Applies To: **2005–07 Accord Hybrid – ALL**  
**2003–05 Civic Hybrid – ALL**  
**2006–11 Civic Hybrid – ALL**

## IMA Battery Software And Hardware Updates

(Supersedes 10-083, dated July 12, 2011, to revise the information marked by the black bars)

## MVCI

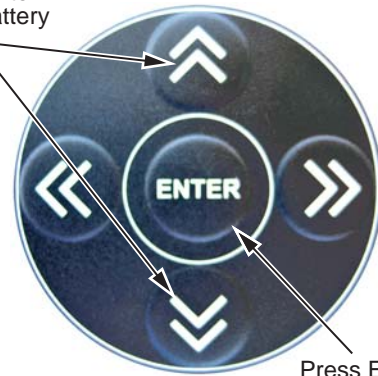
- In Applies To, model years were added.
- Under DETERMINING CORRECT IMA SOFTWARE AND MATCHING IT TO THE IMA BATTERY, the IMA Software Chart was changed.
- Under INSTALLING IMA BATTERY SOFTWARE, the version numbers for the HDS Software and the HDS Control Module Update were changed, and the MVCI illustrations were changed.

- If only the software is being updated, first visually inspect the IMA battery to determine if it's an original or new type. It is possible that a salvaged IMA battery may have been installed without the IMA software being updated. After verifying the IMA battery type, install its matching software by selecting the correct battery code from the IMA Software Chart.
- If an original (no label) IMA battery type is installed in a vehicle that has been updated to new IMA battery type software, make sure to remove the battery code label from the doorjamb, and update the BCM/MCM with the correct software.
- To install IMA software on a hybrid vehicle, select the correct 3-character code from the list on the MVCI. Press ENTER to begin the update.

Use  $\uparrow/\downarrow$  to select battery code.

Press ENTER to confirm each.
